**Advanced Passive 1000 (AP1000)
Generic Technical Specification Traveler (GTST)**

Title: Changes Related to LCO 3.6.8, Containment Penetrations

Figure B 3.6.87-1 (page 1 of 1)
Time Prior to Coolant Inventory Boiling

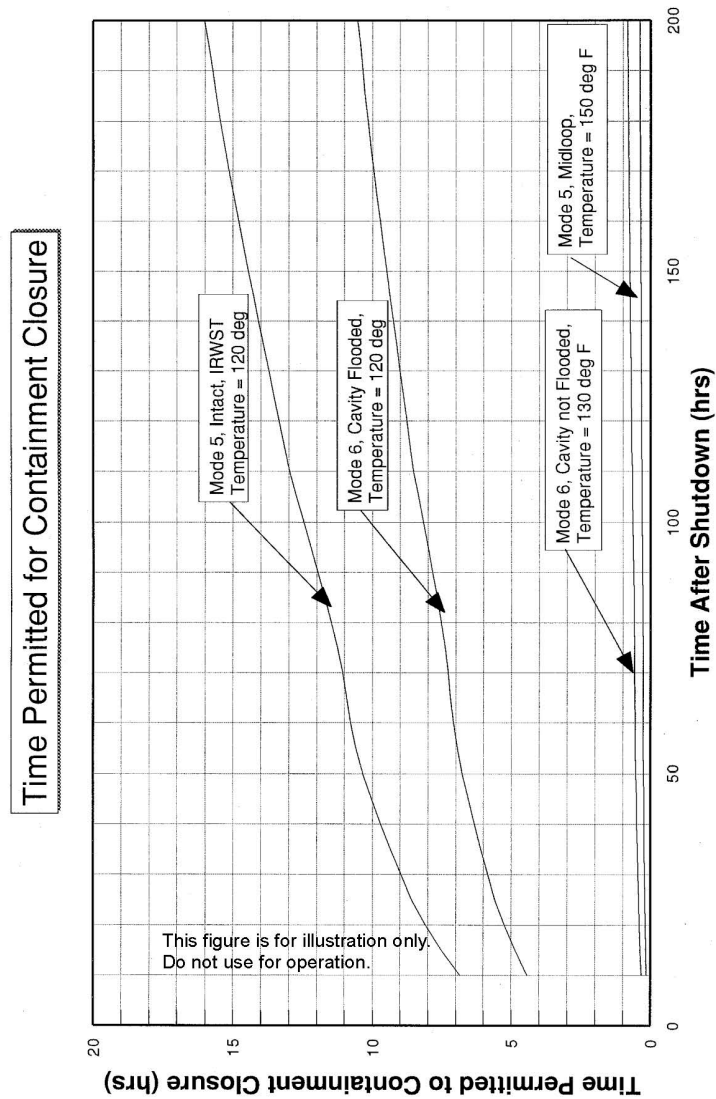
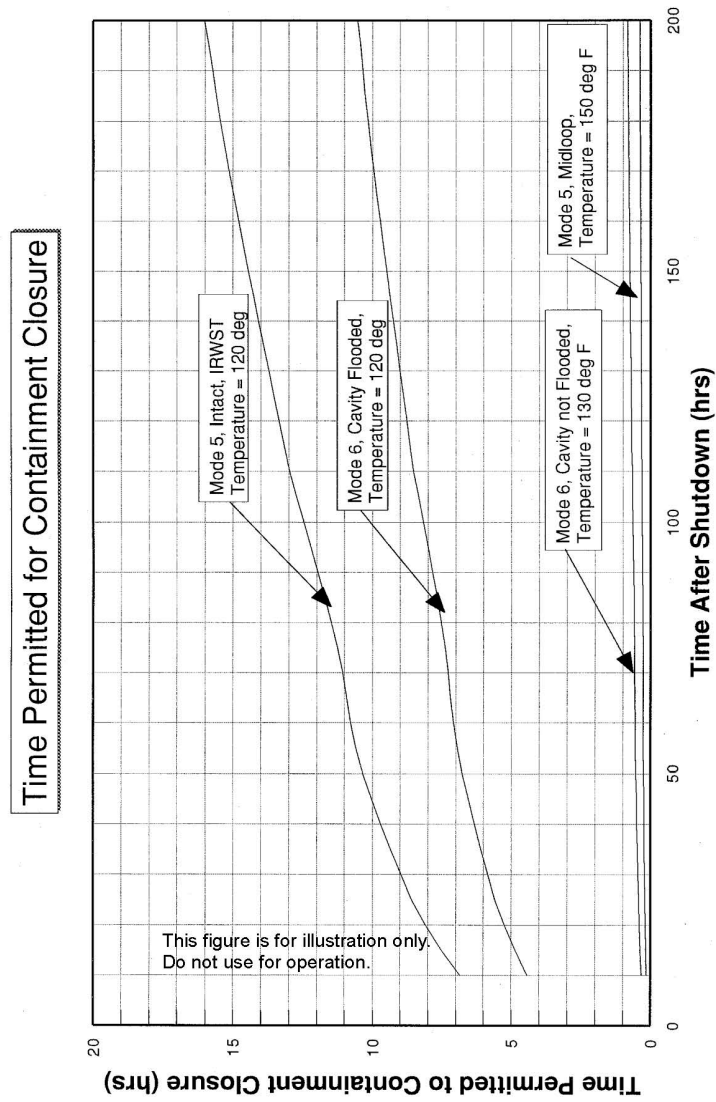
Figure B 3.6.8-1 in the bases is revised by removing brackets from the figure. (COL Item B3.6.8)

VEGP COL Item B3.8.6 removes the brackets from Figure B 3.6.8-1 in the Bases.

VEGP COL Item B3.8.6 removes brackets from Figure B 3.6.8-1 since the figure is for illustration only and should not have been bracketed. VEGP COL Item B3.6.8 (see Reference 2), removal of the Reviewer's Note in B3.6.8 was in error by the applicant. Instead this item was meant to remove the brackets from Figure B 3.6.8-1.

The markup to remove the brackets from figure B 3.6.8-1 was manually done in the Word document.
